Bid Addendum No. 2

Washingtonville Central School District – 2024 Capital Project - Phase 3

CSArch Project No. 228-2401.03

This Bid Addendum No. 2 forms part of the Contract Documents and modifies the original bidding documents dated August 31, 2026. Bid Addendum No. 2 consists of (5) Cover Pages, (1) Specification Sections, (9) 30x42" Drawing Sheets, and Responses to Bidder Requests For Information.

WHS
P001

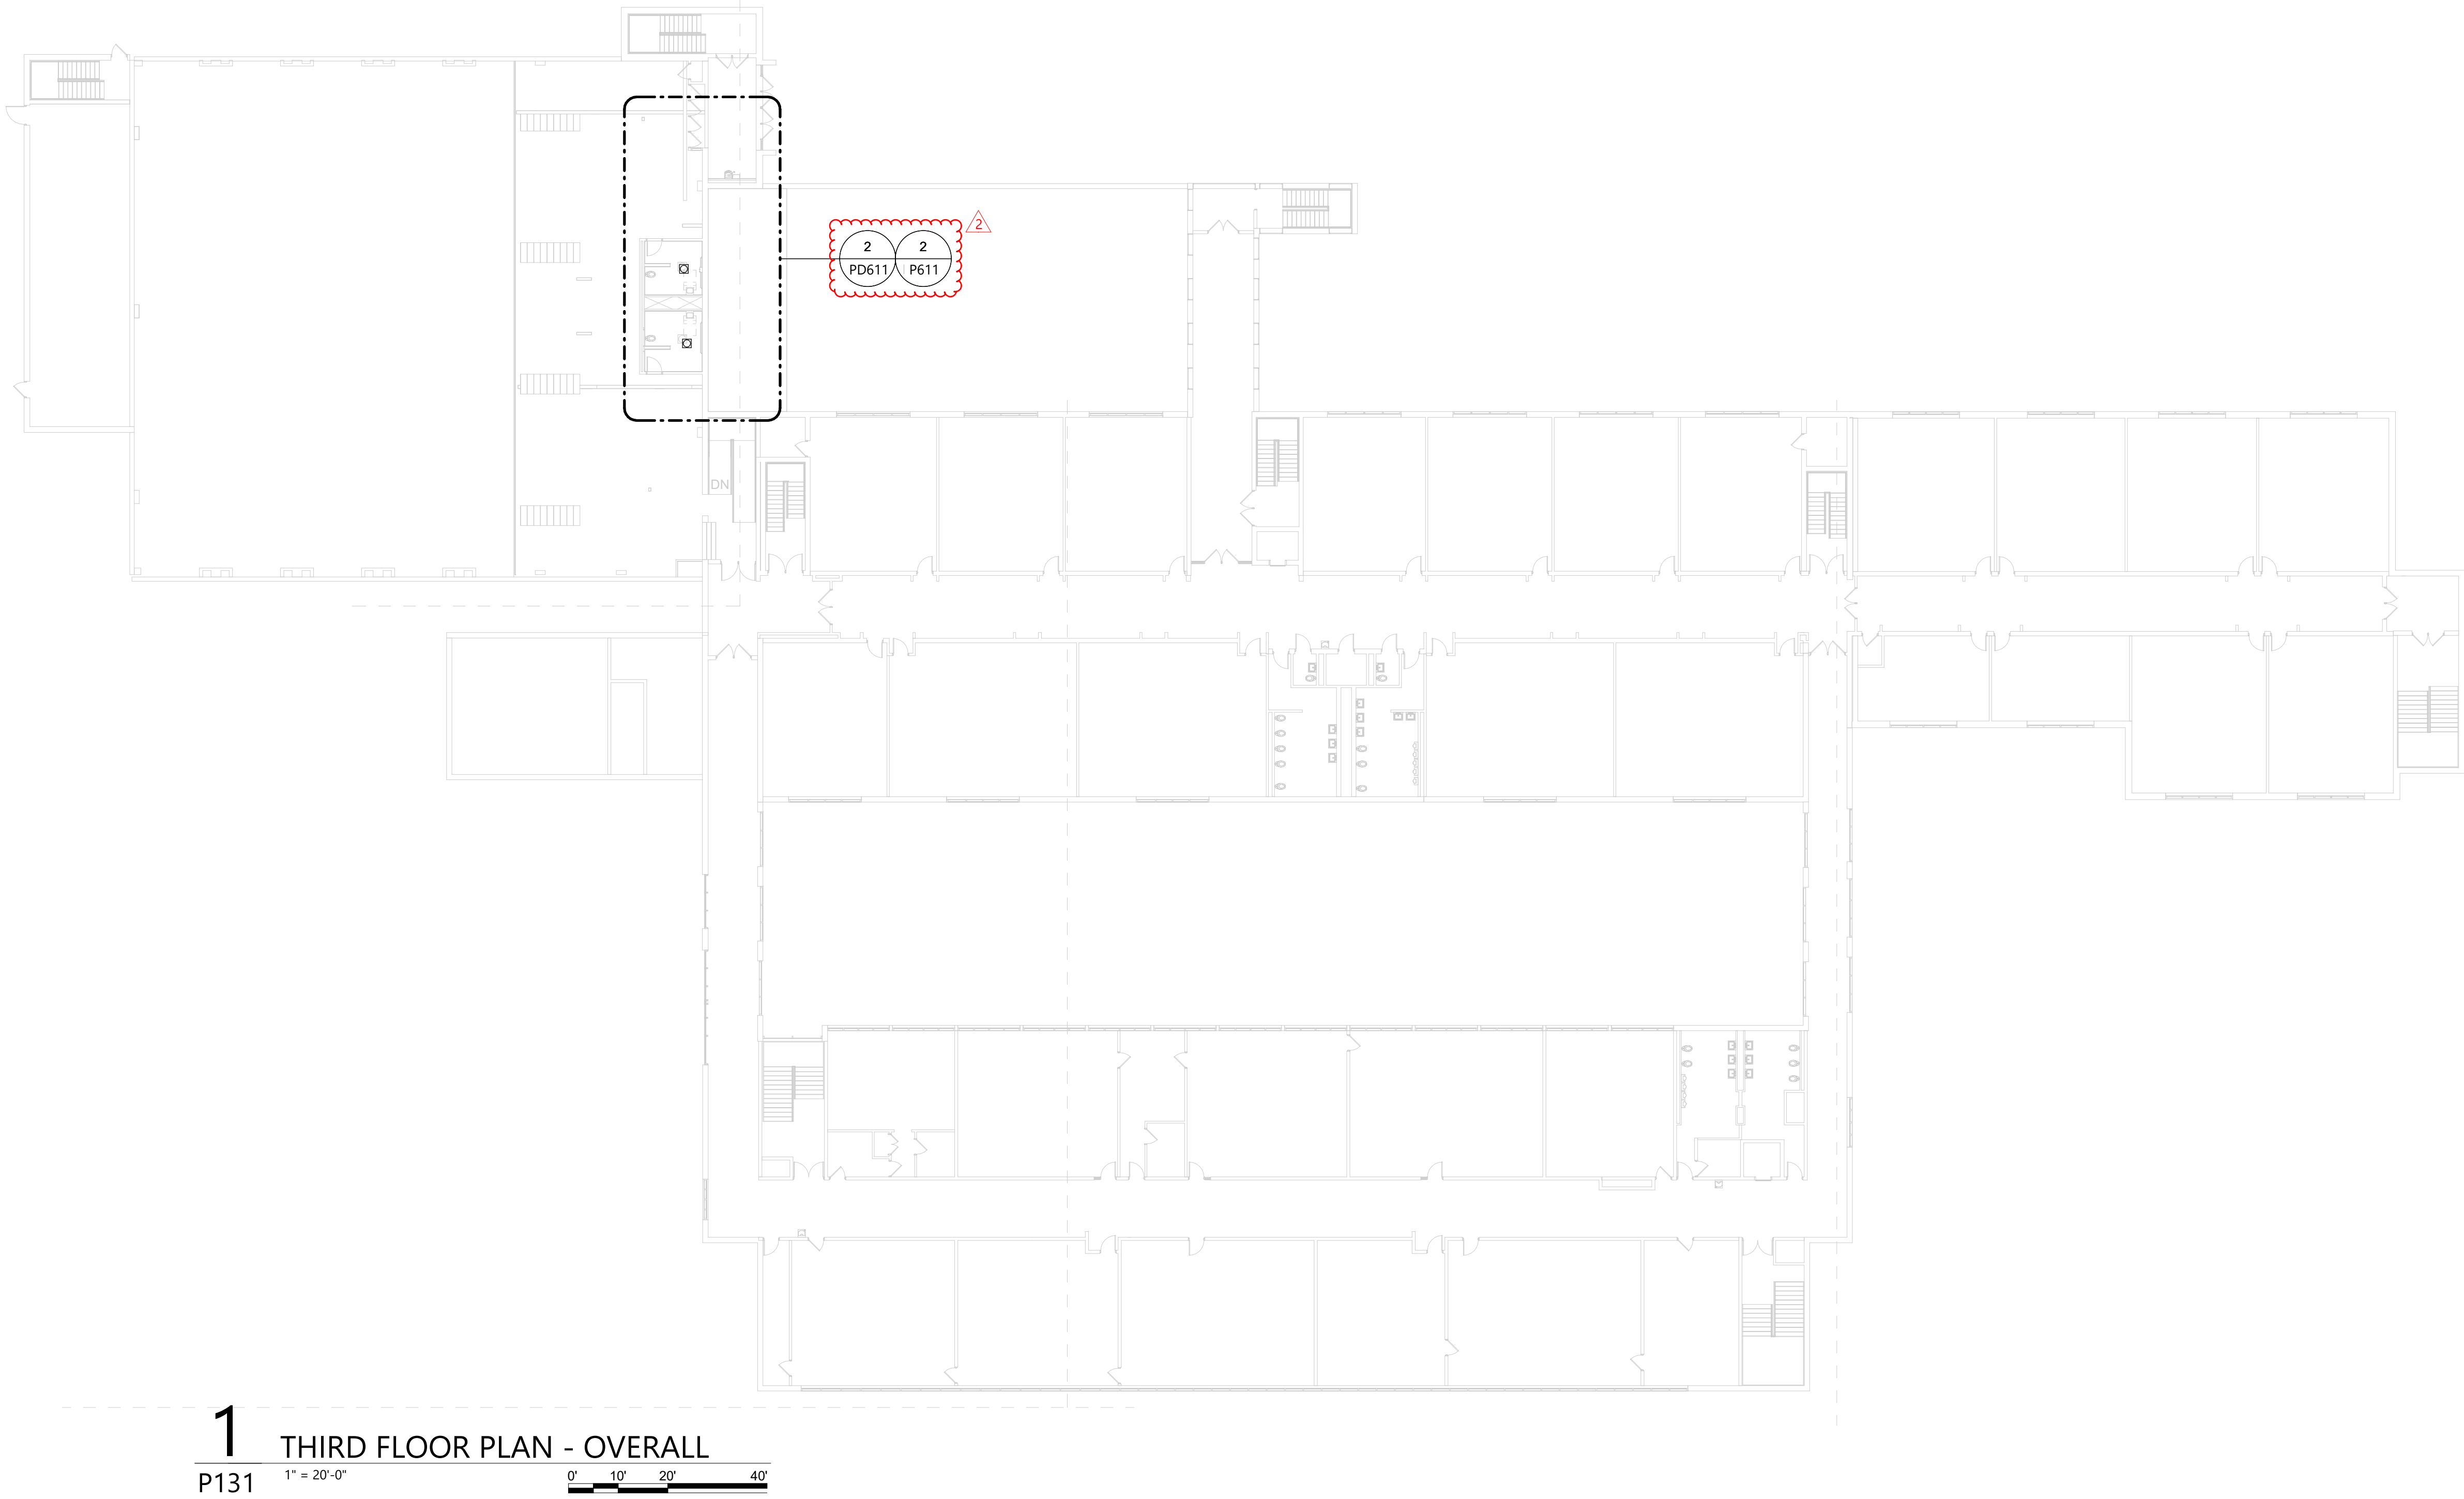
3. Please provide plumbing specs for Floor Drains, Shower A & Shower B, and Electric Water Heaters
 - a. Response: Drawing sheet WHS P001 has been revised per this Bid Addendum #2 to provide additional information on the floor drains and showers. Drawing sheets WHS P001, WHS E121, and WHS E704 have been revised per this Bid Addendum #2 to provide additional information on the electric water heaters. Specification section 224000 – Plumbing Fixtures and Trim has been revised per this Bid Addendum #2 as well.

4. Could you please let us know where I can view the specifications for the shower body mixing valve that will be installed in the pool shower room?
 - a. Response: Drawing sheet WHS P001 has been revised per this Bid Addendum #2 to provide additional information on the shower mixing valves. Specification section 224000 – Plumbing Fixtures and Trim has been revised per this Bid Addendum #2 as well.

Sheet No.
WHS
P131

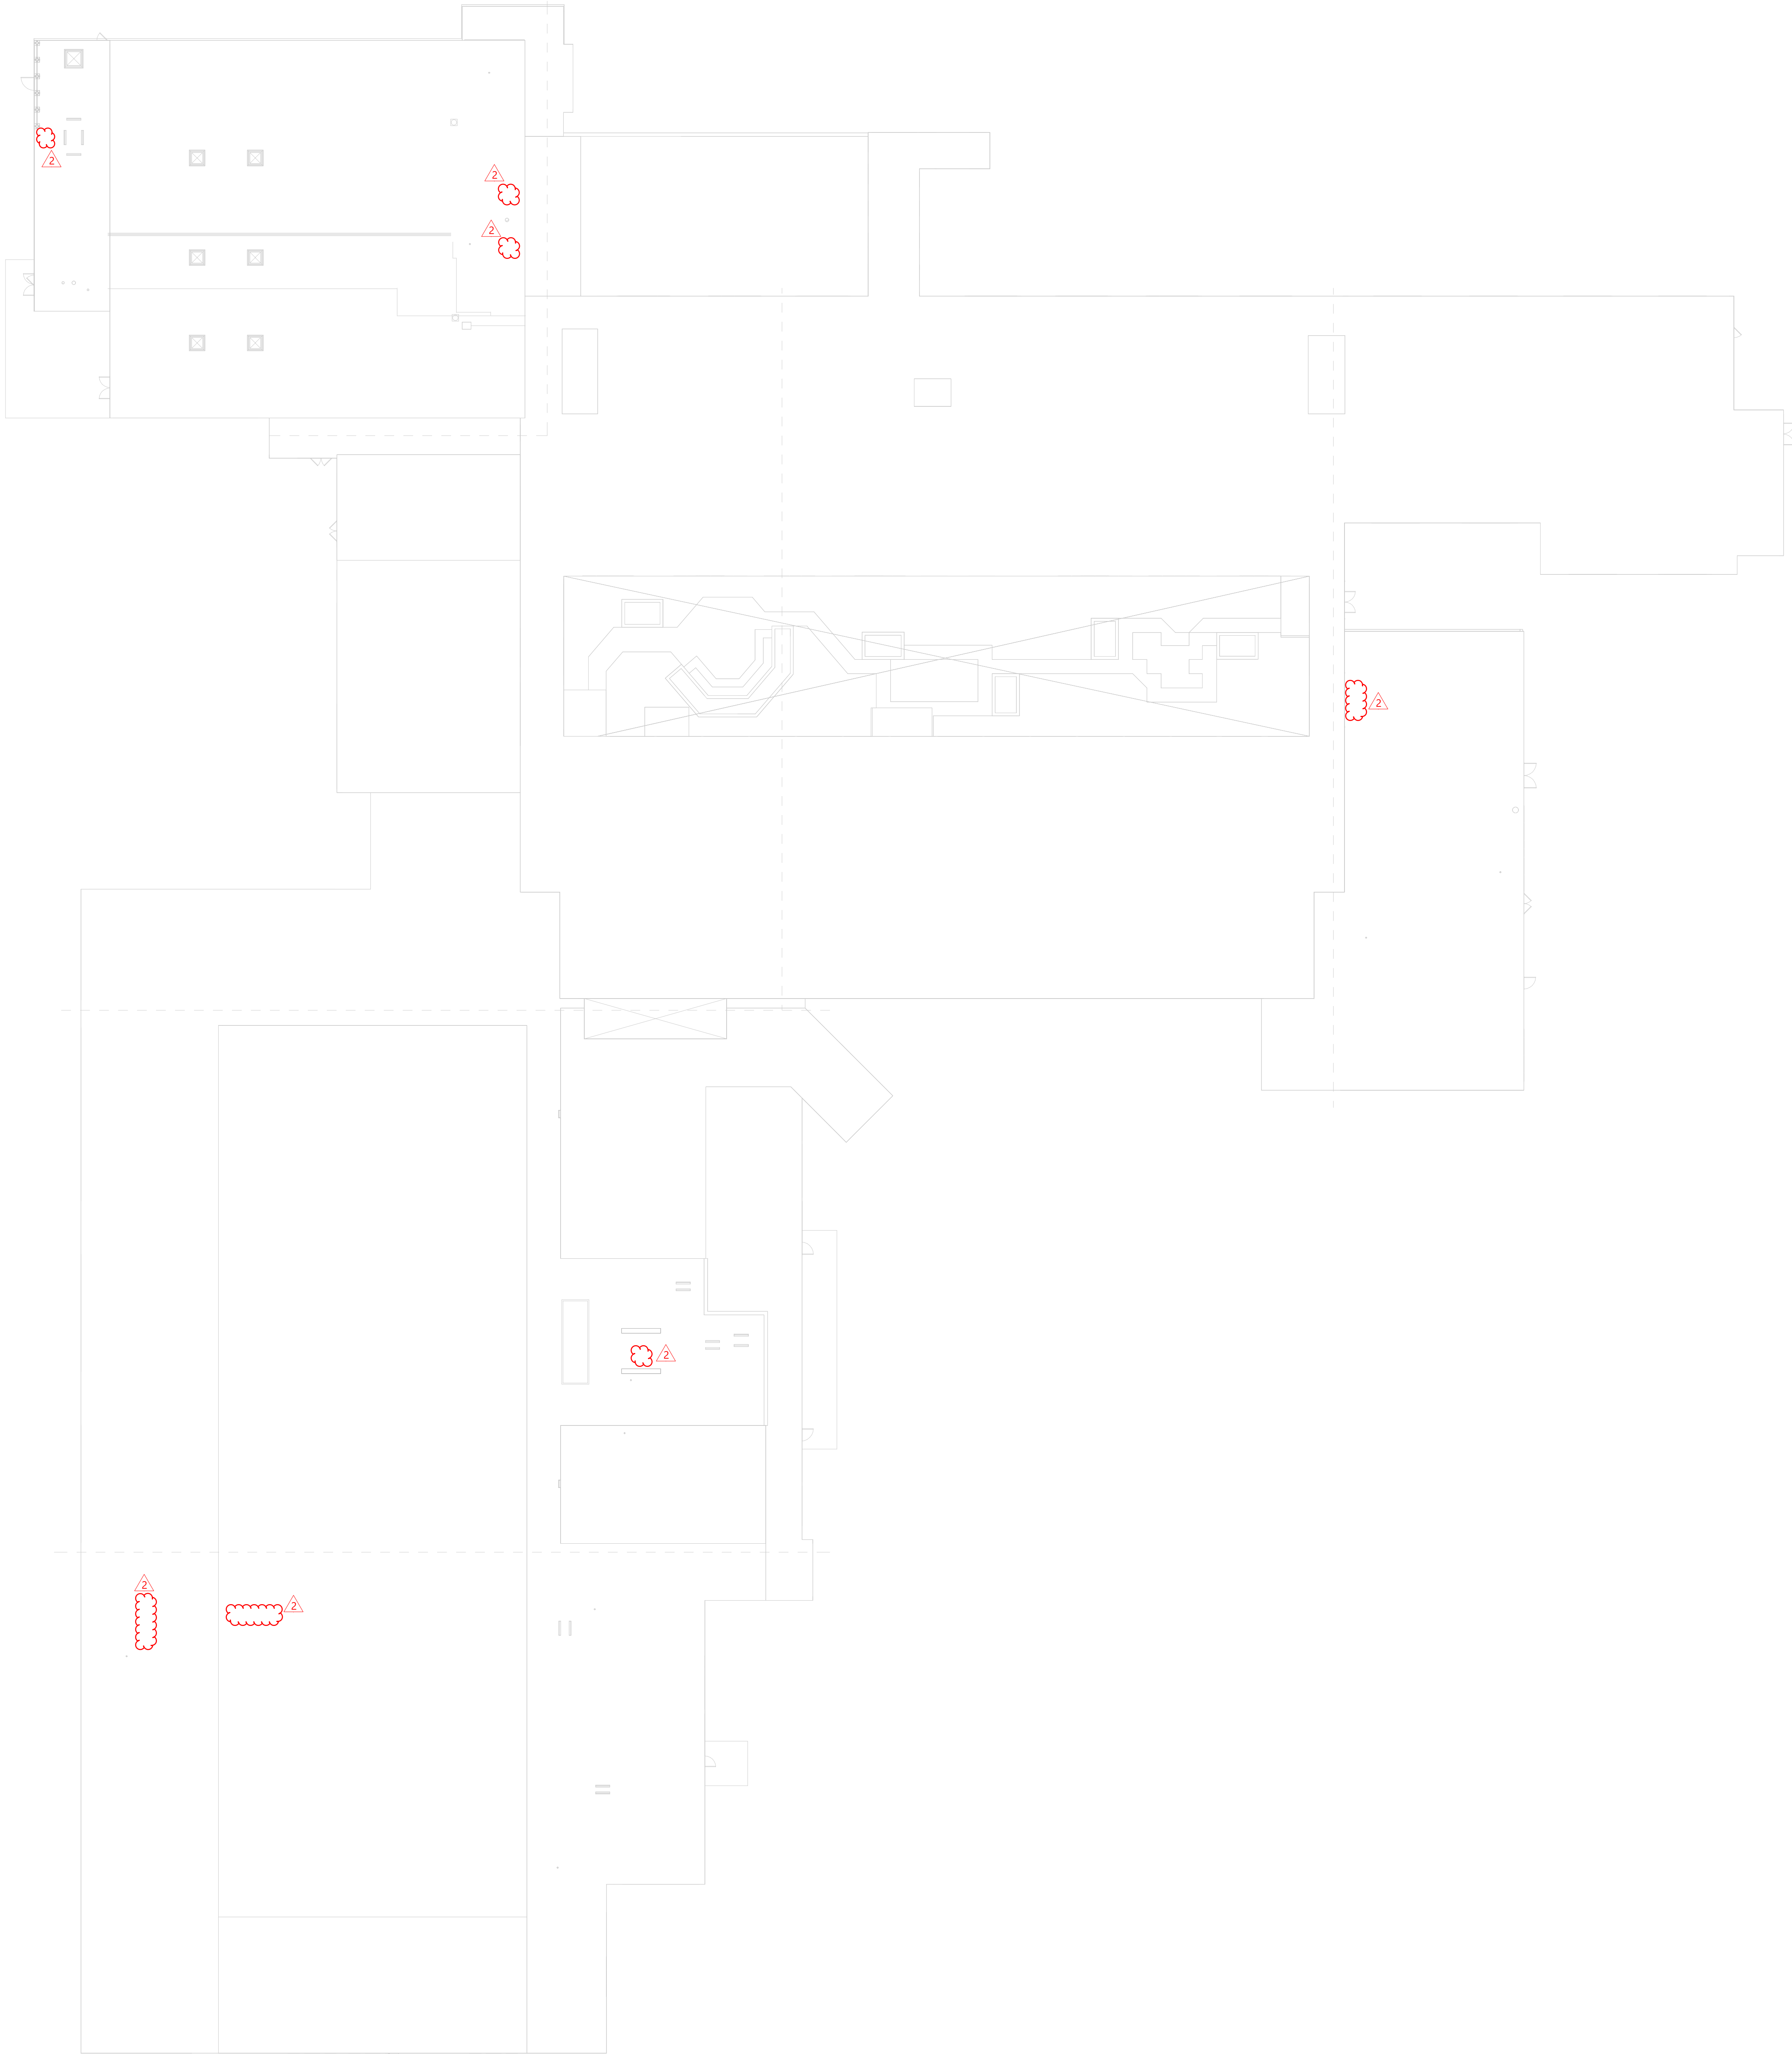
7. Could you please clarify the callout included on WHS P131?
 - a. Response: Drawing sheet WHS P131 has been revised per this Bid Addendum #2 to clarify.
